1120 FRONTENAC AVENUE SW
CALGARY, ALBERTA

DEAN THOMAS
DESIGN GROUP

ISSUED FOR DEVELOPMENT PERMIT: JUNE 29, 2026

| 2. | ISSUED FOR DEVELOPMENT PERMIT (DR1) | JUN 29, 2026 |

A2.1

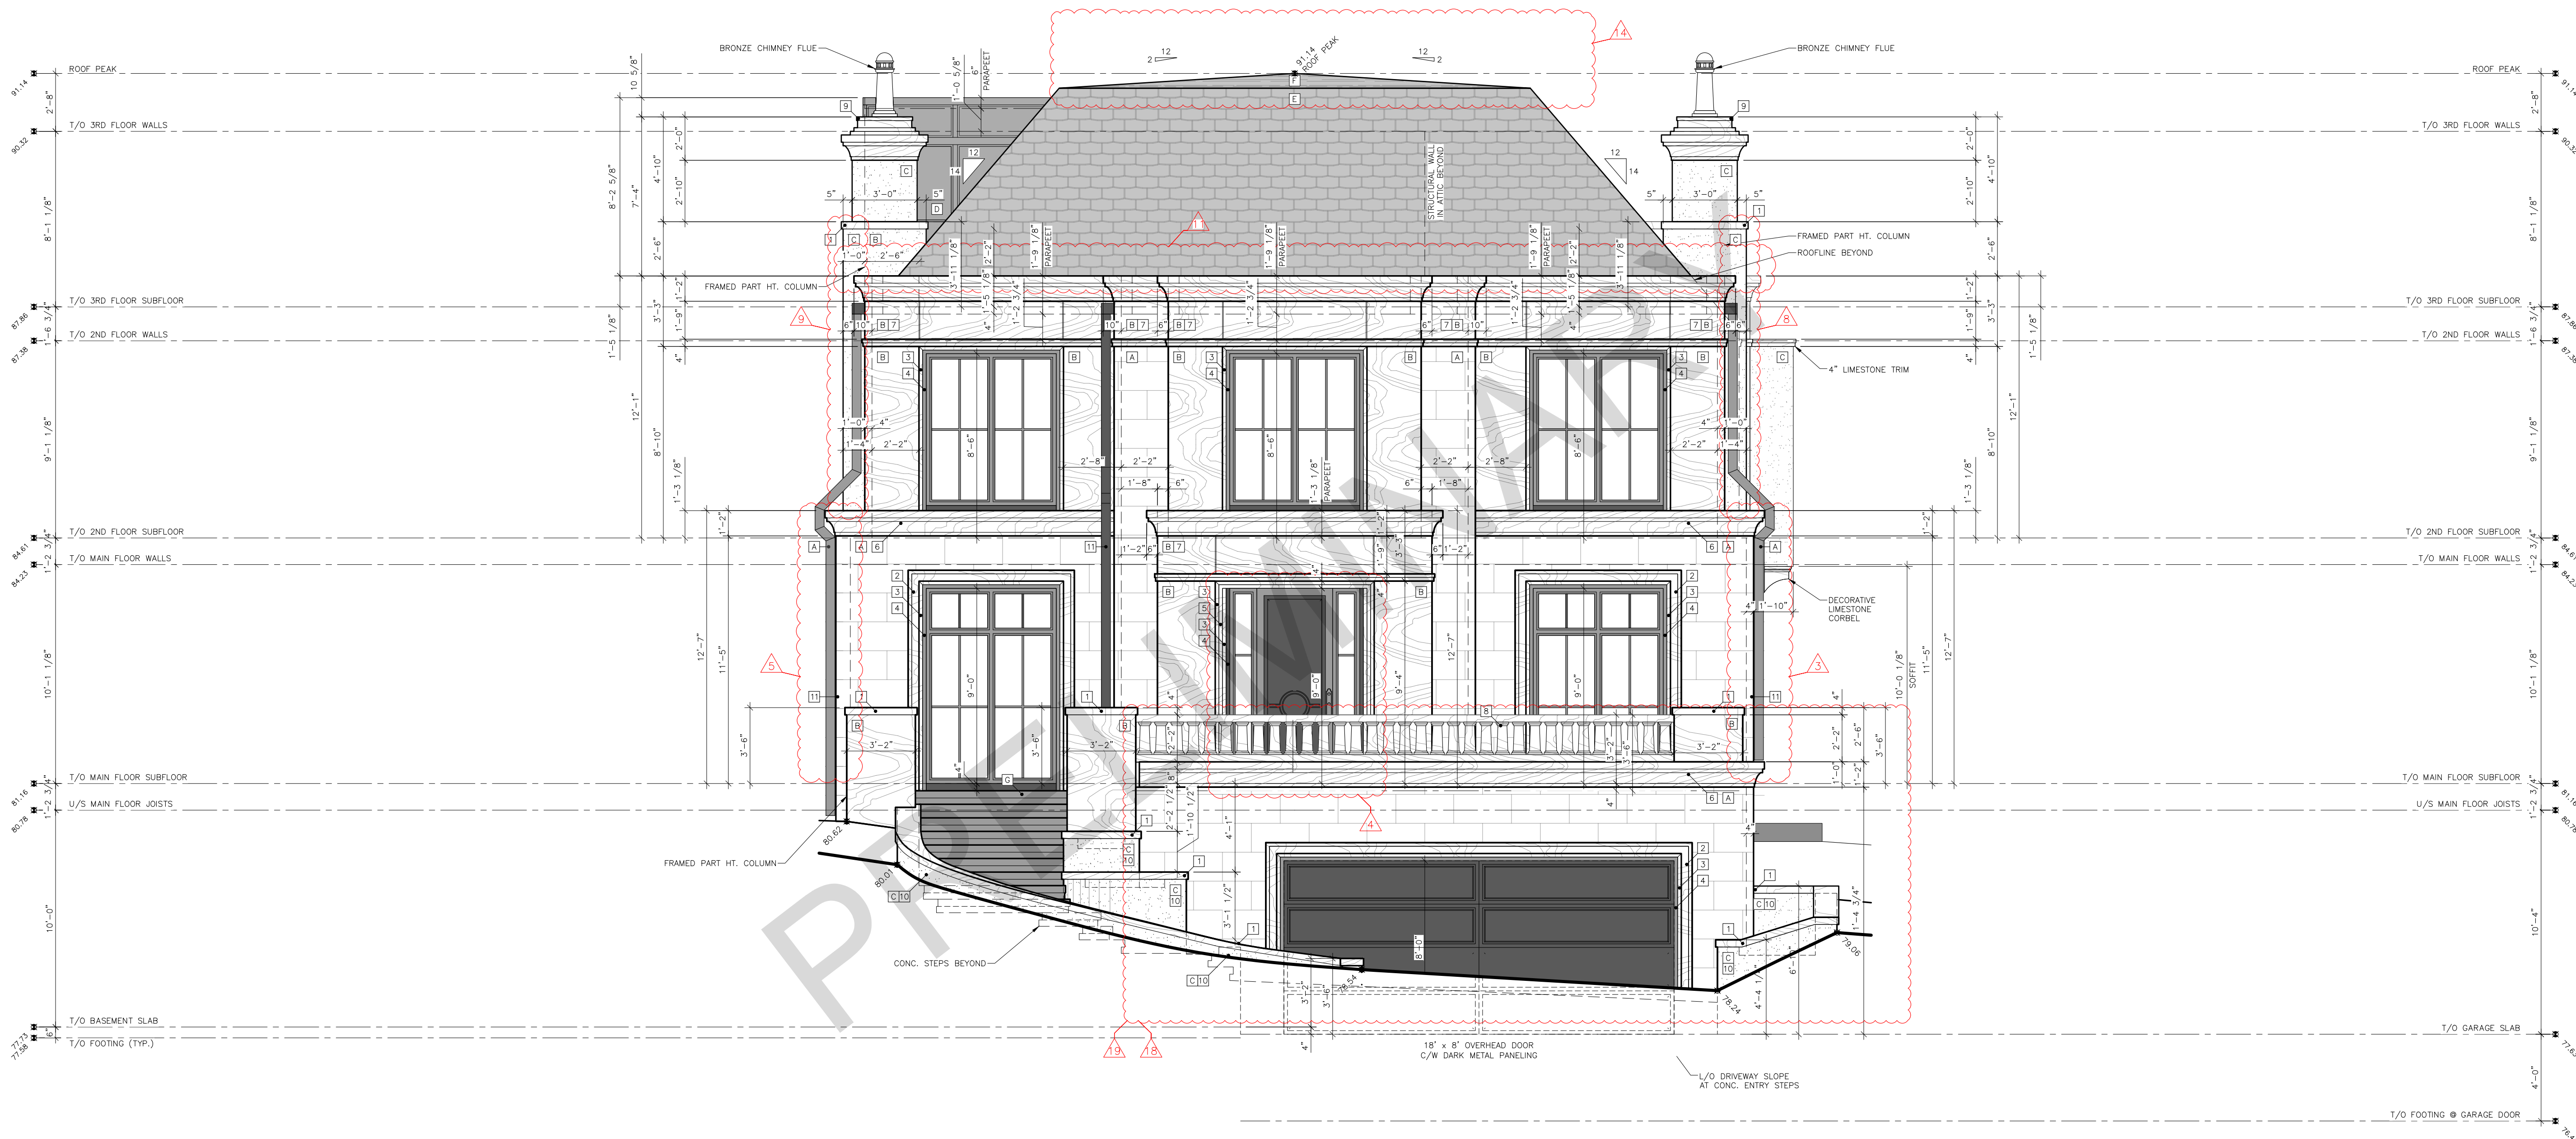
- RIGHT SIDE 14,000" ENG. FLUSH BEAM LOCATION WAS REVISED AND RELOCATED BY 6" TO SUPPORT FRAMED CHIMNEY ABOVE.
- LEFT SIDE 14,000" ENG. FLUSH BEAM LOCATION WAS REVISED AND RELOCATED BY 6" TO SUPPORT FRAMED CHIMNEY ABOVE.

- RIGHT SIDE CHIMNEY BUILD-OUT FRAMING LENGTH WAS REVISED TO 6'-10" X 4' WITH A TOTAL OF 12'-10" X 4' FOR THE FRAMED NATURAL STONE FINISH.
- MAIN DOOR WAS REVISED TO 3'-6" WITH LEFT-SIDE AND RIGHT-SIDE LIGHT OF 1'-3" X 9'-0".

- LEFT SIDE CHIMNEY BUILD-OUT FRAMING LENGTH WAS REVISED TO 6'-10" X 4' WITH A TOTAL OF 12'-10" X 4' FOR THE FRAMED NATURAL STONE FINISH.
- RIGHT SIDE CHIMNEY 14,000" ENG. FLUSH BEAM LENGTH WAS REVISED TO 5'-6".

- LEFT SIDE CHIMNEY 14,000" ENG. FLUSH BEAM LENGTH WAS REVISED TO 5'-6".
- RIGHT SIDE CHIMNEY AT SECOND FLOOR LEVEL WAS REVISED TO 6'-0" X 4".
- LEFT SIDE CHIMNEY AT SECOND FLOOR LEVEL WAS REVISED TO 6'-0" X 4".

- FRONT STONE BALUSTERS AND NEWEL POST WERE REMOVED. PARAPET TO REMAIN.
- FRONT STONE BALUSTERS AND PARAPET WERE REMOVED. ROOFING TO CONTINUE TO EDGE OF FRONT PARAPET.

- REAR STONE BALUSTERS WERE REVISED TO GLASS RAILINGS.
- ASPHALT TORCHED ON ROOFING AREA WAS REVISED TO TILE ON PEDESTAL NEWEL POST AND GLASS RAILING WERE ADDED.

- ROOF PEAK WAS REVISED TO #9:14. ASPHALT TORCH ON ROOFING FINISH TO REMAIN.
- FRONT ROOFING SLOPE WAS REVISED TO 14:12 SLOPE.
- ENTRY WALKWAY MATERIAL DIFFERENTIATION FOR HERITAGE.

- WINDOW CHANGED TO DOOR.
- DRIVEWAY RECONFIGURED TO SINGLE WIDE, FRONT STAIR WALL CURVE ADDED.
- EXTENDED FRONT DECK 12" FURTHER BEYOND FRONT GARAGE DOOR.

A2.2

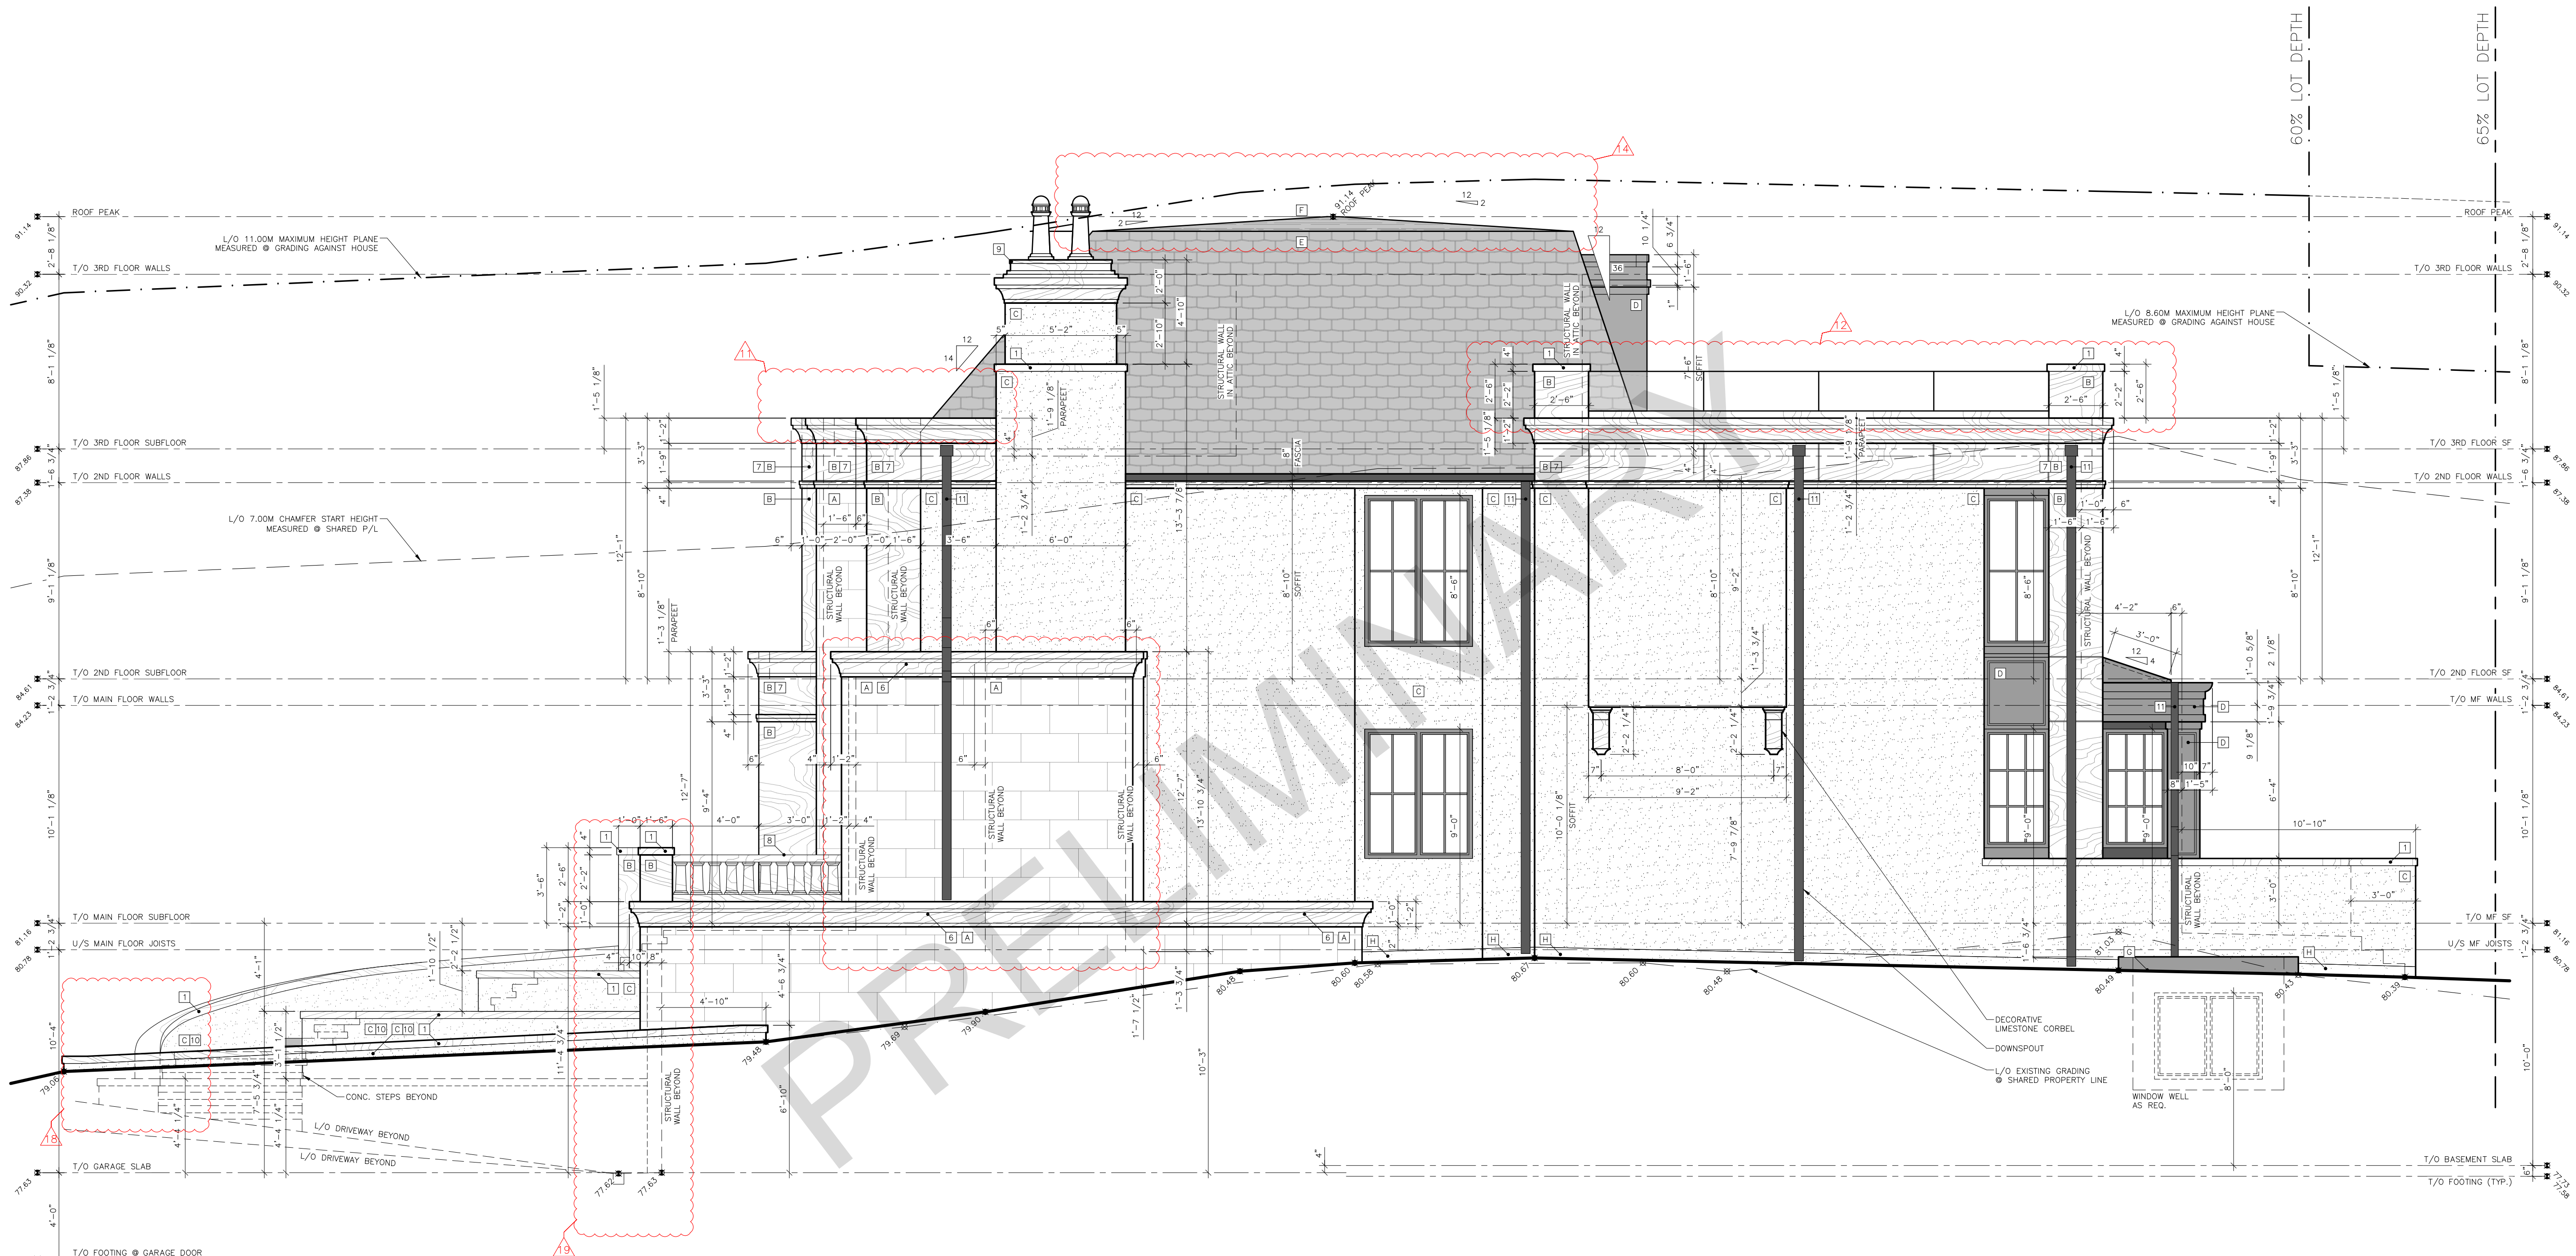
- RIGHT SIDE 14.000" ENG. FLUSH BEAM LOCATION WAS REVISED AND RELOCATED BY 6" TO SUPPORT FRAMED CHIMNEY ABOVE.
- LEFT SIDE 14.000" ENG. FLUSH BEAM LOCATION WAS REVISED AND RELOCATED BY 6" TO SUPPORT FRAMED CHIMNEY ABOVE.

- RIGHT SIDE CHIMNEY BUILD-OUT FRAMING LENGTH WAS REVISED TO 6'-10" X 4" WITH A TOTAL OF 12'-10" X 4" FOR THE FRAMED NATURAL STONE FINISH.
- MAIN DOOR WAS REVISED TO 3'-6" WITH LEFT-SIDE AND RIGHT-SIDE LIGHT OF 1'-3" X 9'-0".

- LEFT SIDE CHIMNEY BUILD-OUT FRAMING LENGTH WAS REVISED TO 6'-10" X 4" WITH A TOTAL OF 12'-10" X 4" FOR THE FRAMED NATURAL STONE FINISH.
- RIGHT SIDE CHIMNEY 14.000" ENG. FLUSH BEAM LENGTH WAS REVISED TO 5'-6".

- LEFT SIDE CHIMNEY 14.000" ENG. FLUSH BEAM LENGTH WAS REVISED TO 5'-6".
- RIGHT SIDE CHIMNEY AT SECOND FLOOR LEVEL WAS REVISED TO 6'-0" X 4".
- LEFT SIDE CHIMNEY AT SECOND FLOOR LEVEL WAS REVISED TO 6'-0" X 4".

- FRONT STONE BALUSTERS AND NEWEL POST WERE REMOVED. PARAPET TO REMAIN.
- FRONT STONE BALUSTERS AND PARAPET WERE REMOVED. ROOFING TO CONTINUE TO EDGE OF FRONT PARAPET.

- REAR STONE BALUSTERS WERE REVISED TO GLASS RAILINGS.
- ASPHALT TORCHED ON ROOFING AREA WAS REVISED TO TILE ON PEDESTAL. NEWEL POST AND GLASS RAILING WERE ADDED.

- ROOF PEAK WAS REVISED TO +91.14. ASPHALT TORCH ON ROOFING FINISH TO REMAIN.
- FRONT ROOFING SLOPE WAS REVISED TO 14:12 SLOPE.
- ENTRY WALKWAY MATERIAL DIFFERENTIATION FOR HERITAGE.

- WINDOW CHANGED TO DOOR.
- DRIVEWAY RECONFIGURED TO SINGLE WIDE, FRONT STAIR WALL CURVE ADDED.
- EXTENDED FRONT DECK 12" FURTHER BEYOND FRONT GARAGE DOOR.

A2.4

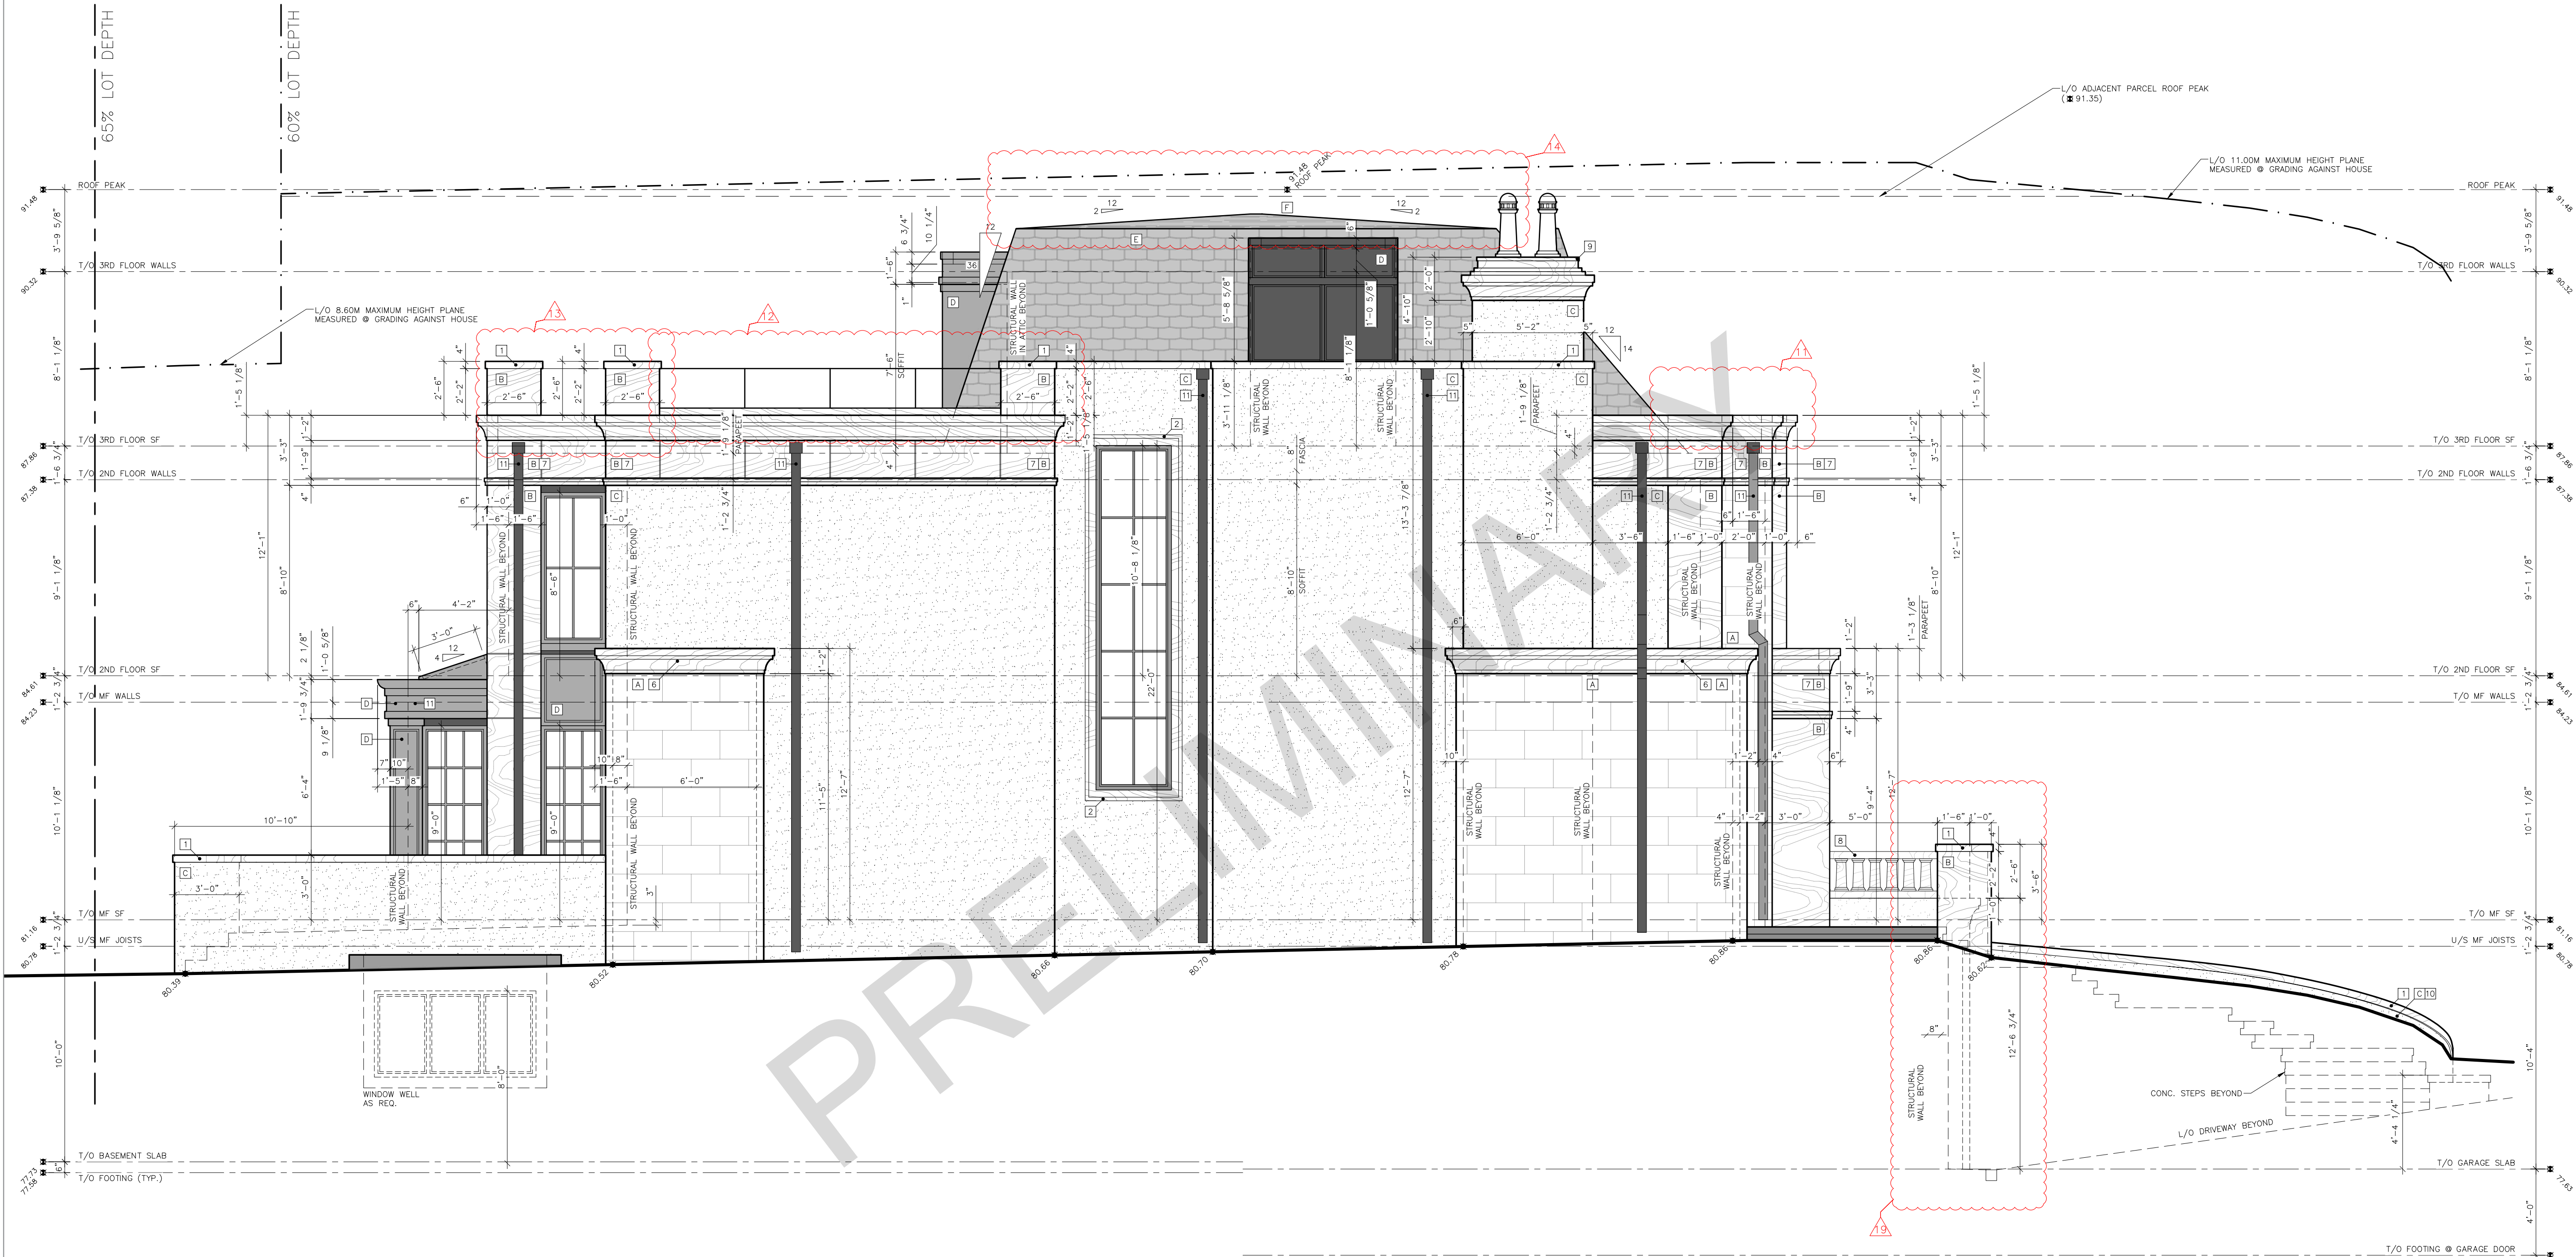
- RIGHT SIDE 14,000" ENG. FLUSH BEAM LOCATION WAS REVISED AND RELOCATED BY 6" TO SUPPORT FRAMED CHIMNEY ABOVE.
- LEFT SIDE 14,000" ENG. FLUSH BEAM LOCATION WAS REVISED AND RELOCATED BY 6" TO SUPPORT FRAMED CHIMNEY ABOVE.

- RIGHT SIDE CHIMNEY BUILD-OUT FRAMING LENGTH WAS REVISED TO 6'-10" X 4' WITH A TOTAL OF 12'-10" X 4' FOR THE FRAMED NATURAL STONE FINISH.
- MAIN DOOR WAS REVISED TO 3'-6" WITH LEFT-SIDE AND RIGHT-SIDE LIGHT OF 1'-3" X 9'-0".

- LEFT SIDE CHIMNEY BUILD-OUT FRAMING LENGTH WAS REVISED TO 6'-10" X 4' WITH A TOTAL OF 12'-10" X 4' FOR THE FRAMED NATURAL STONE FINISH.
- RIGHT SIDE CHIMNEY 14,000" ENG. FLUSH BEAM LENGTH WAS REVISED TO 5'-6".

- LEFT SIDE CHIMNEY 14,000" ENG. FLUSH BEAM LENGTH WAS REVISED TO 5'-6".
- RIGHT SIDE CHIMNEY AT SECOND FLOOR LEVEL WAS REVISED TO 6'-0" X 4".
- LEFT SIDE CHIMNEY AT SECOND FLOOR LEVEL WAS REVISED TO 6'-0" X 4".

- FRONT STONE BALUSTERS AND NEWEL POST WERE REMOVED. PARAPET TO REMAIN.
- FRONT STONE BALUSTERS AND PARAPET WERE REMOVED. ROOFING TO CONTINUE TO EDGE OF FRONT PARAPET.

- REAR STONE BALUSTERS WERE REVISED TO GLASS RAILINGS.
- ASPHALT TORCHED ON ROOFING AREA WAS REVISED TO TILE ON PEDESTAL, NEWEL POST AND GLASS RAILING WERE ADDED.

- ROOF PEAK WAS REVISED TO +91.14, ASPHALT TORCH ON ROOFING FINISH TO REMAIN.
- FRONT ROOFING SLOPE WAS REVISED TO 14:12 SLOPE.
- ENTRY WALKWAY MATERIAL DIFFERENTIATION FOR HERITAGE.

- WINDOW CHANGED TO DOOR.
- DRIVEWAY RECONFIGURED TO SINGLE WIDE, FRONT STAIR WALL CURVE ADDED.
- EXTENDED FRONT DECK 12" FURTHER BEYOND FRONT GARAGE DOOR.
